PD Modification Application: PRS 21-0591

**Hillsborough
County Florida**

Development Services Department

Request: Minor Modification to PD

2.3 Approved Site Plan (partial provided below for size and orientation purposes. See Section 8.1 for full site plan)

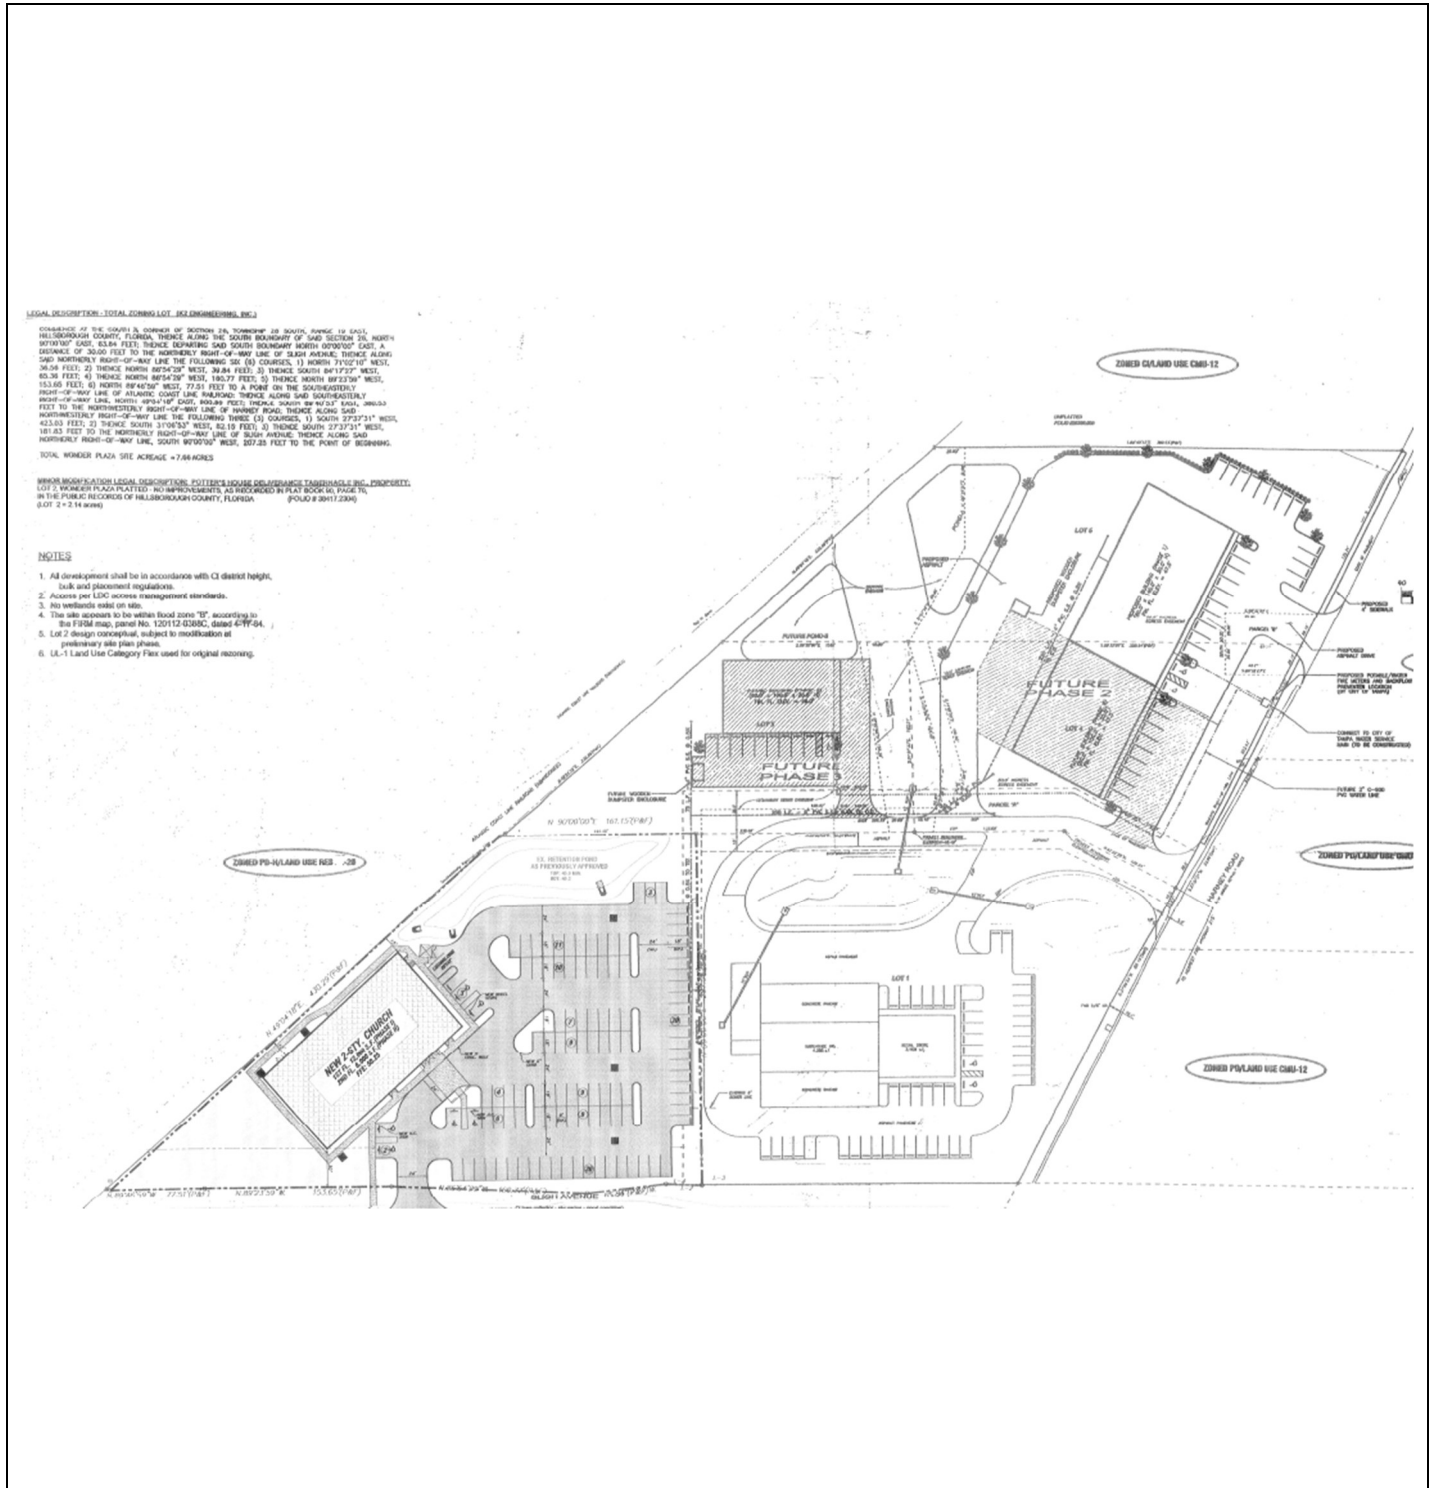
The request is for a minor modification to a planned development (PD 92-0176). The purpose of the modification is to relocate a building, associated parking and stormwater facilities. The existing PD consists of 4 parcels totaling 7.66 acres approved for business/professional office, warehouse use and a 18,000 sq. ft. church. Only two of the parcels are being modified as part of the PRS. The applicant is not proposing to introduce any new uses as part of this modification.

2.4 Proposed Site Plan (partial provided below for size and orientation purposes. See Section 8.2 for full site plan)

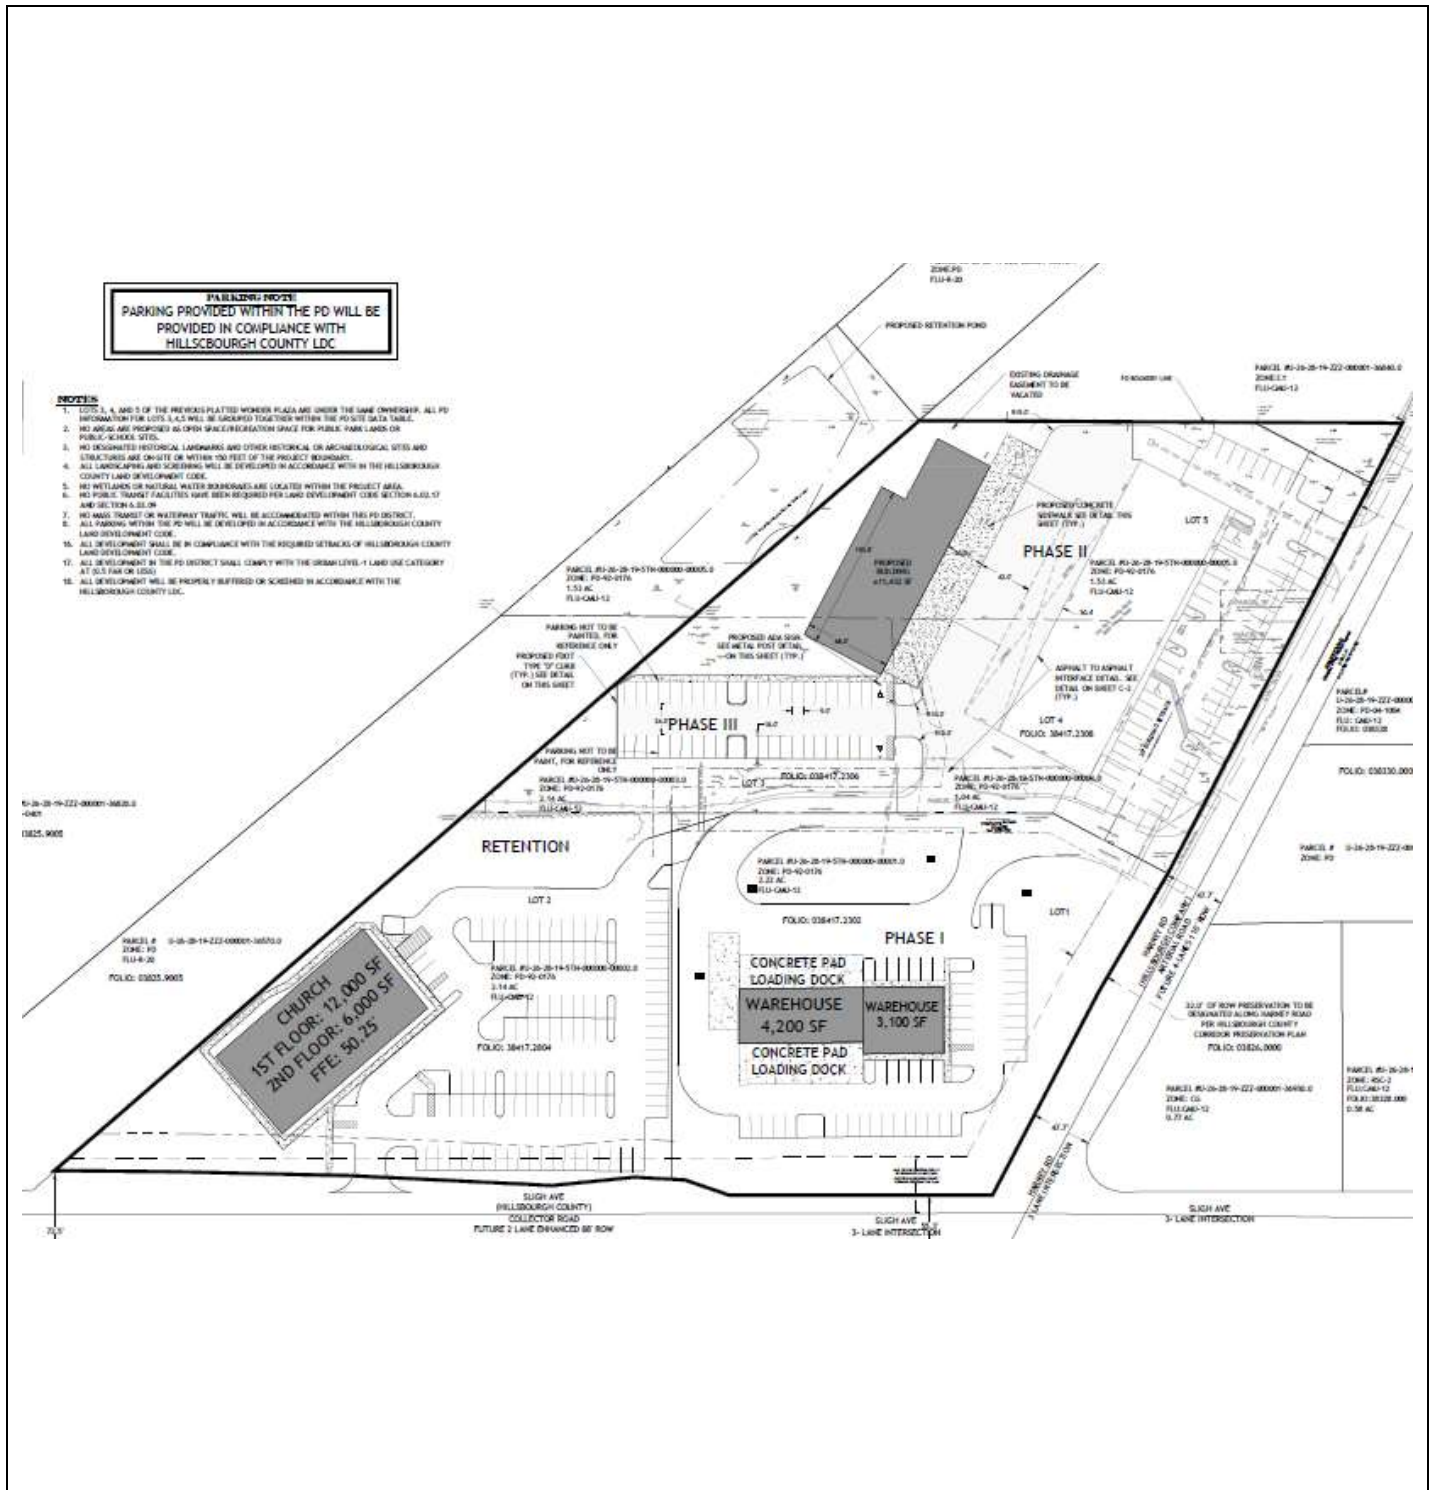
The property is located at the northwest corner of Sligh Ave. and Harney Rd. The applicant is seeking to modify existing Planned Development zoning (PD 92-176 / PRS 10-0357) to relocate a building, associated parking and stormwater facilities; and increase in size, the relocated building from 6,000 to 11,432 square feet. The Future Land Use is CMU-12. The applicant is not proposing to introduce any new uses and is not proposing to increase the floor area ratio (FAR) above the allowable FAR as part of this modification.

Hillsborough County, Comprehensive Plan Policy 1.4 defines compatibility as the characteristics of different uses or activities or design which allow them to be located near or adjacent to each other in harmony. Some elements affecting compatibility include the following: height, scale, mass and bulk of structures, pedestrian or vehicular traffic, circulation, access and parking impacts, landscaping, lighting, noise, odor and architecture. Compatibility refers to the sensitivity of development proposals in maintaining the character of existing development. The proposed Minor Modification is compatible with the surrounding uses.

Staff finds that the project with the proposed development standards, existing scale and restrictions is compatible with the area. The proposed intensity is comparable with nearby non-residential uses within the PD and immediately abutting the subject folios. Therefore, based on these considerations, staff finds the minor modification request approvable, with conditions.

Approval - Approval of the request, subject to the conditions listed below, is based on the general site plan submitted July 23, 2021. Previous conditions not carried forward are shown as strikethrough, and new conditions are shown as underlined.
